Department of Energy
Office of Legacy Management

Subject: Transmittal of Modification to Rocky Flats Legacy Management Agreement (RFLMA) Attachment 1, Site Map and Attachment 2, Legacy Management Requirements, for approval

Proposed 2010 Modifications to Attachment 2—Legacy Management Requirements of the Rocky Flats Legacy Management Agreement (RFLMA)

Proposed 2010 Modifications to Attachment 2—Legacy Management Requirements of the Rocky Flats Legacy Management Agreement (RFLMA) Comment Responsiveness Summary

Figure 1. Water Monitoring at Rocky Flats

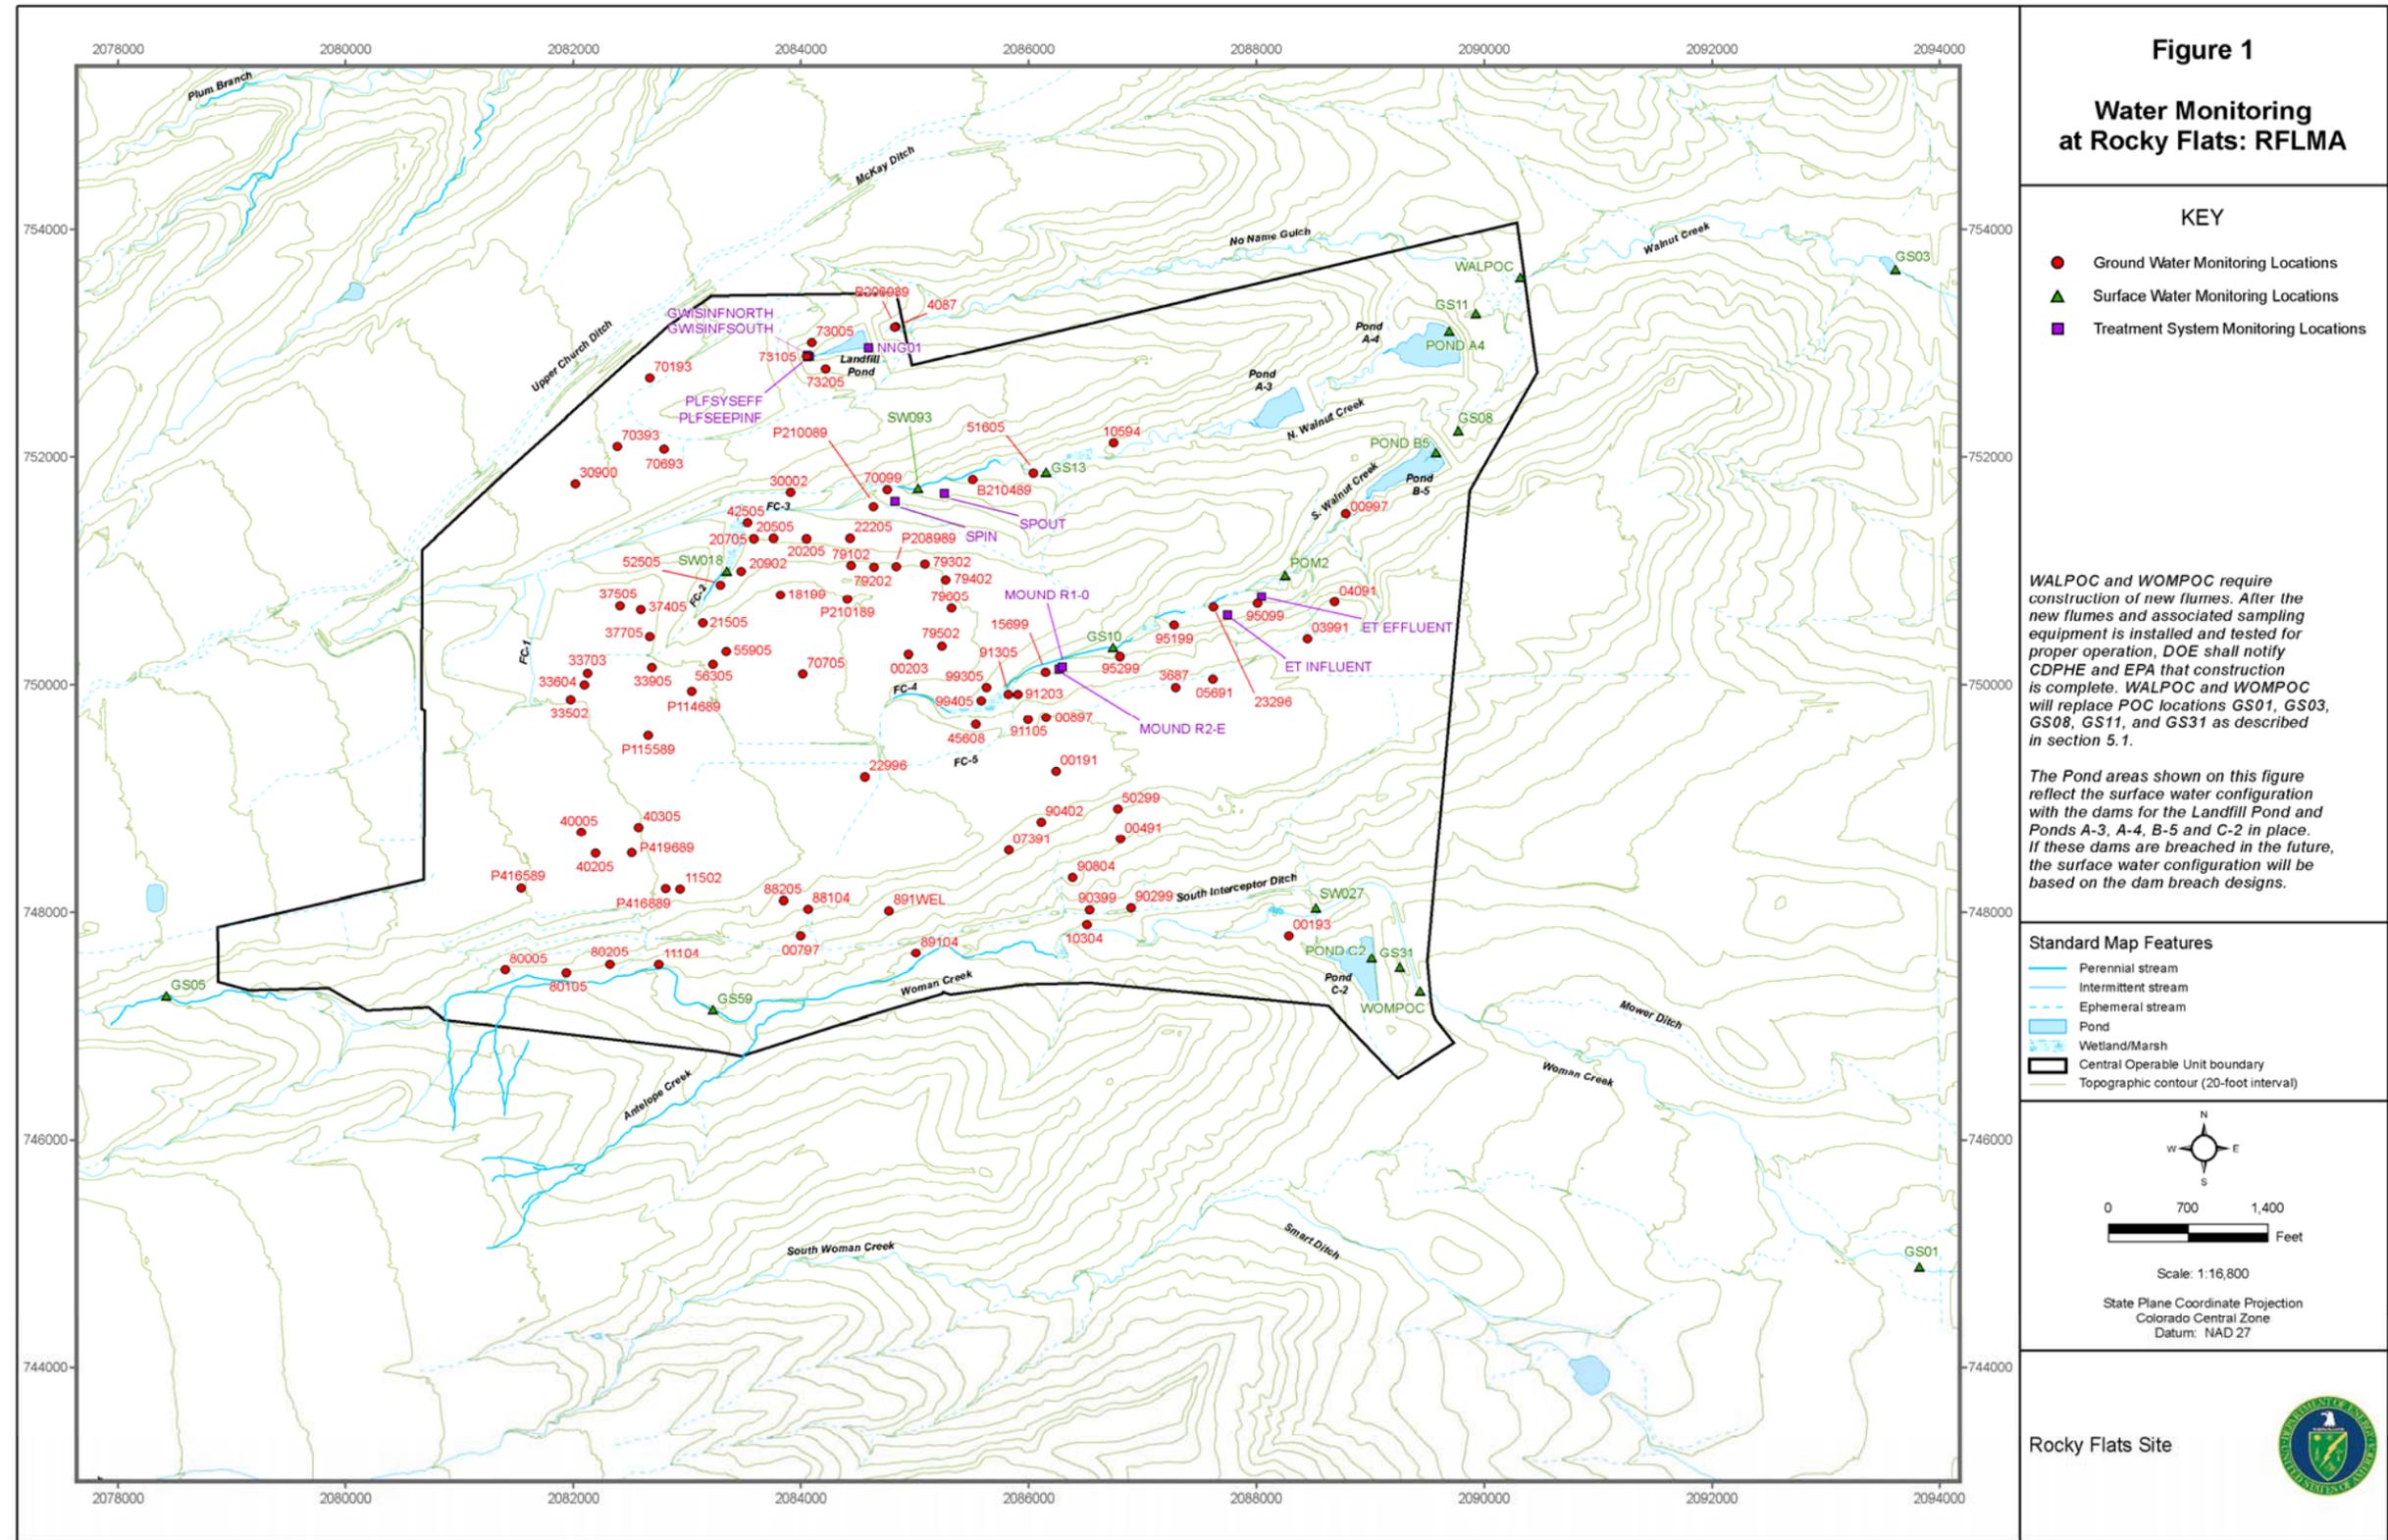
No.	Comment	DOE Response
46	<p>Proposed Figure 1 Water Monitoring at Rocky Flats - Page 26</p> <p>The proposed sequence and dates for the dam breaching listed in the right hand margin do not correspond to the verbal information provided by DOE. Regardless, the original figure should be retained since the justification for the new monitoring sites are based on plans to breach the terminal dams which have not been approved.</p>	<p>The proposed Figure 1 information was intended to inform the public about the proposed monitoring point locations. Because DOE is evaluating breaching the dams, the surface water configuration of the listed ponds may change, depending on the outcome of DOE's decision.</p> <p>The approved modification of Figure 1 shows the current configuration and indicates when the new POCs will become effective.</p>
47	<p>Figure 5 Points of Compliance - Page 30</p> <p>No changes to the figure should be made since the changes are based on the assumption that the dams have been breached. In addition, Reportable Conditions and evaluation of compliance with remedy performance standards for Nitrate must be based on a 30-day average, not a 12-month rolling average, to adhere to the chronic standards listed in State WQCC Regulations Nos. 31 and 38.</p>	<p>RFLMA Attachment 2, Section 2.1, specifies that RFLMA surface water standards are based on the Tables in Colorado WQCC Regulations 31 and 38. Regulation 31 recognizes CDPHE's and EPA's authority to approve criteria that may be different than that adopted by the Commission.</p> <p>Regulation 31 (Section 31.11, Section 5) says: "Nothing in this regulation shall be interpreted to preclude: (a) An agency responsible for implementation of the Comprehensive Environmental Response, Compensation and Liability Act (CERCLA), 42 U.S.C. 9601 et seq., as amended, from selecting a remedial action that is more or less stringent than would be achieved by compliance with the statewide numerical standards established in this section, or alternative site-specific standards adopted by the commission, where a determination is made that such a variation is authorized pursuant to the applicable provisions of CERCLA."</p> <p>RFLMA Attachment 2, Figure 5, "Points of Compliance," documents the evaluation protocol approved by CDPHE and EPA for implementation of the remedy. The RFLMA Parties have determined that the approved RFLMA protocols allow for appropriate comparison of water monitoring data to Colorado water quality standards to demonstrate that water is of sufficient quality to support all uses.</p>

Figure 6. Points of Evaluation

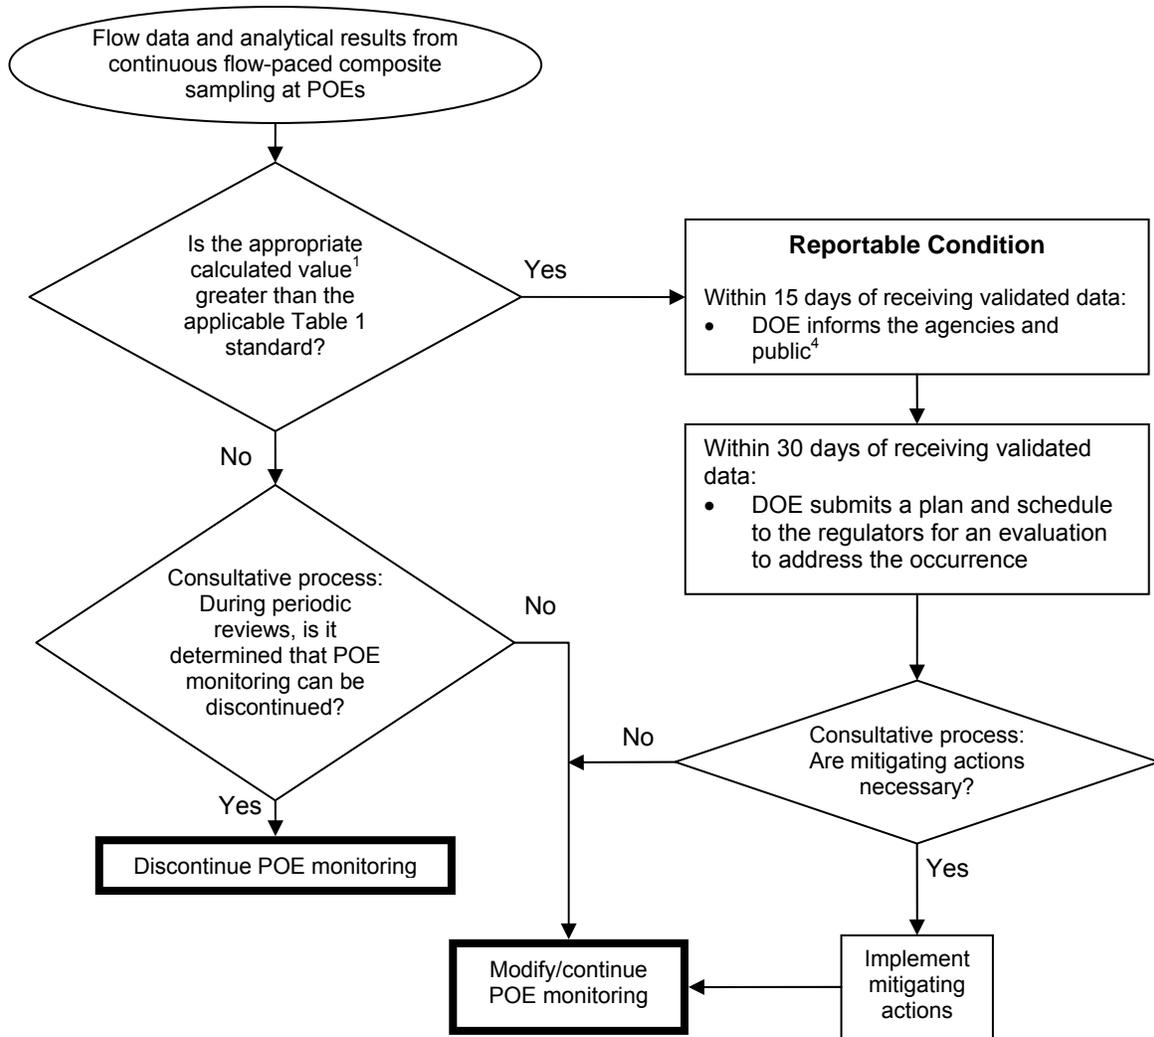
No.	Comment	DOE Response
48	<p>Figure 6 Points of Evaluation - Page 31</p> <p>The method of calculation for all applicable analytes should be based on a 30-day average instead of the 12-month rolling average since these monitoring site are intended to serve as an early warning system. Accordingly, footnote 2 regarding the 12-month rolling average should also be deleted.</p>	<p>See Common Concern Statement 7 and the response to Comment 5.</p>
49	<p>Figure 7 Area of Concern Wells, Boundary Wells, and SWO18 - Page 32</p> <p>The existing figure should be retained as is, without any of the changes proposed by DOE.</p>	<p>See the response to Comment 34.</p> <p>The approved modification does not include Boundary wells as RFLMA monitoring locations.</p>
50	<p>Figure 11 Groundwater Treatment Systems - Page 36</p> <p>The following revisions should be made to the flow chart: Box that states "Sample PLFPONDEFF⁷ NNG01⁷ " should be deleted since there is no need to construct a new surface water monitoring site downstream of the PLFSYSEFF if the Present Landfill pond is breached. PLFSYSEFF is the appropriate monitoring location since it is where discharges to surface water occurs and it is as close as possible to the source of contamination.</p>	<p>See the response to Comment 43.</p> <p>The location NNG01 is a grab sample location. There is no construction involved for this location.</p>

Figure 7. Area of Concern Wells and SW018

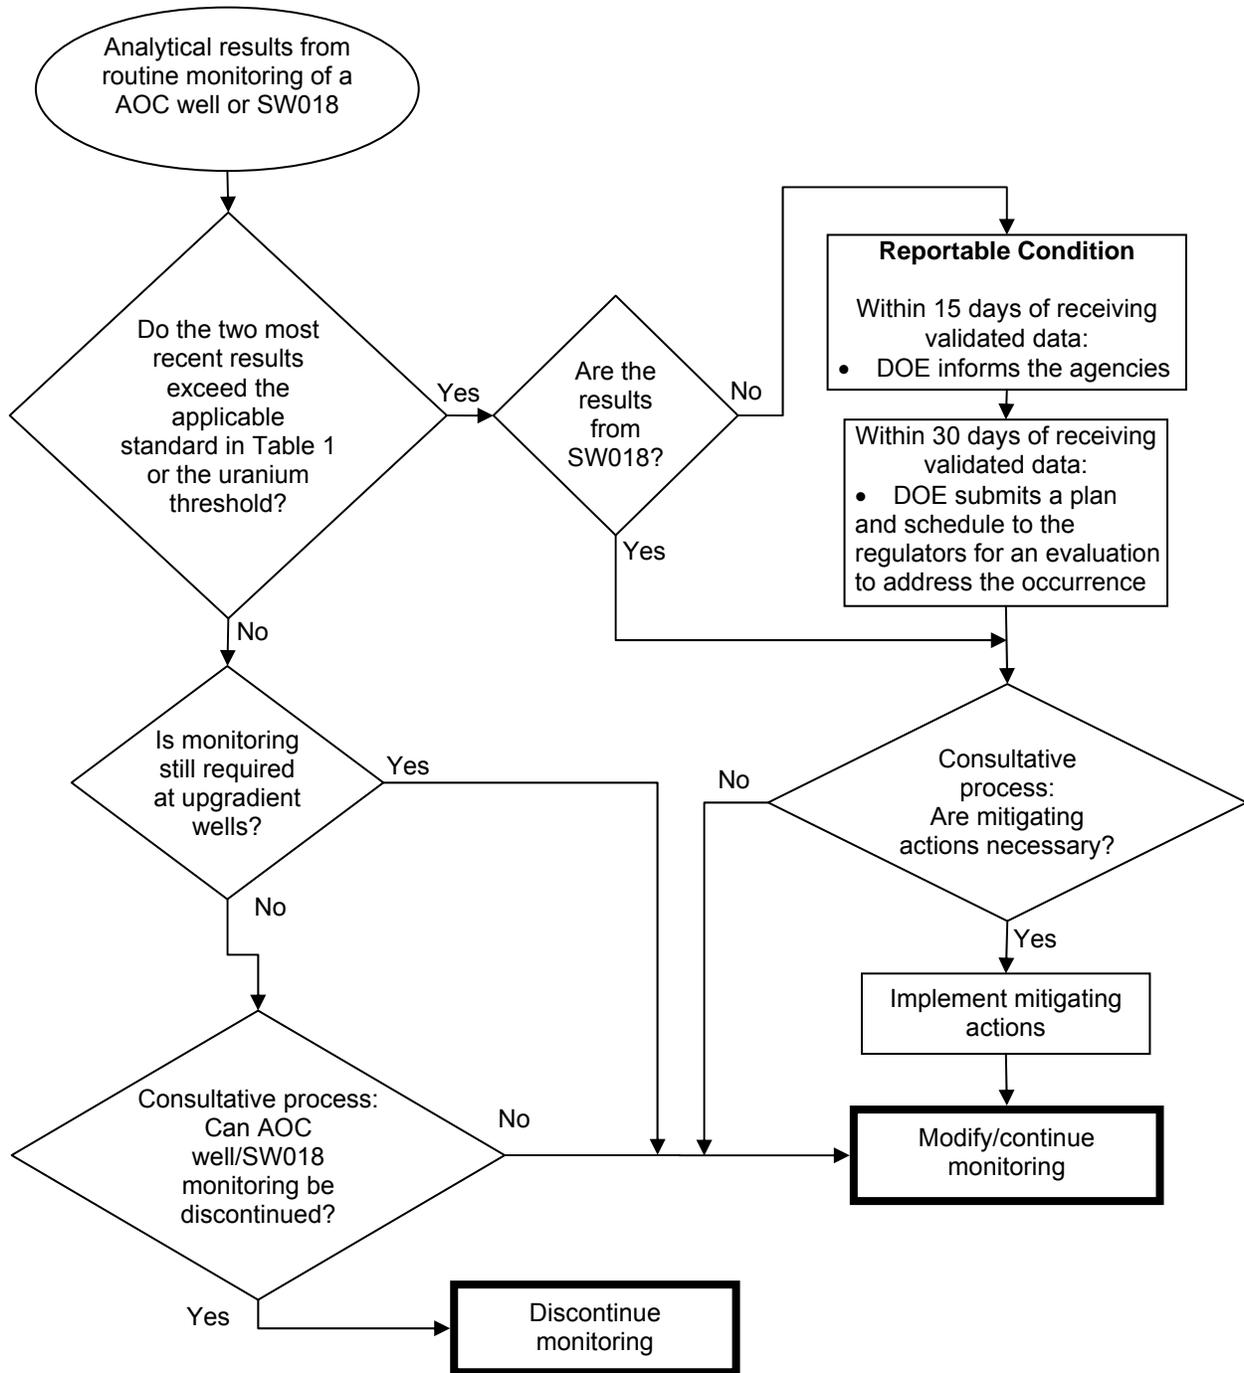
106	<p>Page 32, Figure 7 Northglenn objects to the deletion of the Boundary Wells. The DOE performs groundwater flow calculations to estimate movement of pollutant plumes. Northglenn requests the DOE consider our recommendation (detailed in the next sentence) rather than discontinuing monitoring if the two most recent sampling results do not exceed the standard. Northglenn requests that the DOE use flow calculations to determine when the pollutant might reach the well. If the pollutant plume is not measured within the modeled/estimated time, then the flow</p>	<p>No changes were proposed for AOC or Sentinel wells and none are included in the approved modifications. The RFLMA Parties will continue to inform downstream communities and the public in accordance with the RFLMA Public Involvement Plan regarding any proposed changes to RFLMA monitoring locations.</p> <p>The flowchart would allow AOC well monitoring to be discontinued if monitoring is no longer required at up gradient (Evaluation and Sentinel) wells. This comment appears to agree with the decision logic in RFLMA Attachment 2, Figure 7. Note also that whether monitoring</p>

Figure 9. Evaluation Wells

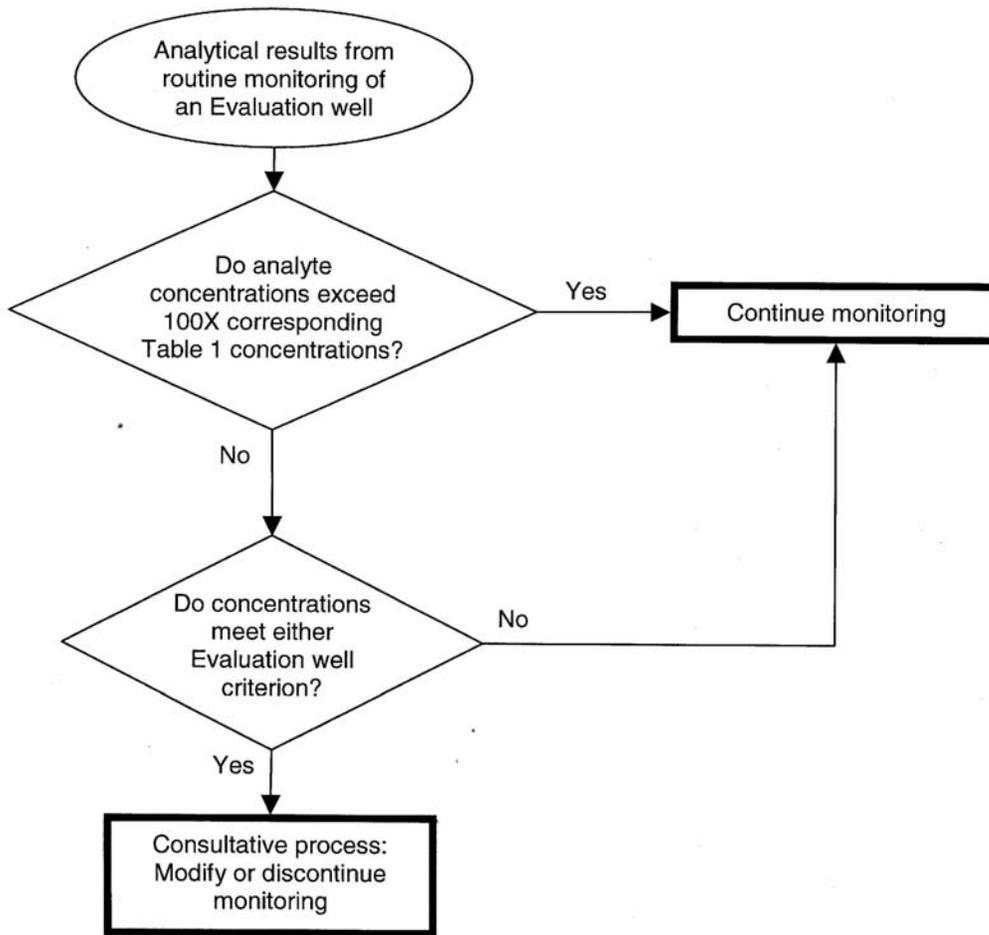
No.	Comment	DOE Response
108	Page 34, Figure 9 Same questions as Figure 8 on the criteria.	See the response to Comment 107. No changes were proposed for Evaluation wells and none are included in the approved modifications.
109	Page 35, Figure 10 Northglenn requests to be notified of proposed changes to RCRA wells.	No changes were proposed for RCRA wells and none are included in the approved modifications.
110	Northglen Requests: DOE withdraw the proposed modifications to the RFLMA Attachment 2 and maintain the document in the current state.	Comment noted.
111	Northglen Requests: DOE withdraw the dam breaching EA and CDPHE rescind the contact record related to breaching terminal dams until such time as the inconsistencies between the RFLMA and the EA can be worked out.	Comment noted. See the response to Comment 7.
112	Northglen Requests: The formation of a working group composed of downstream communities, USFWS, and the regulators for the purpose of discussing and reaching agreements on water quality issues.	See Common Concern Statement 3 and the response to Comment 12.
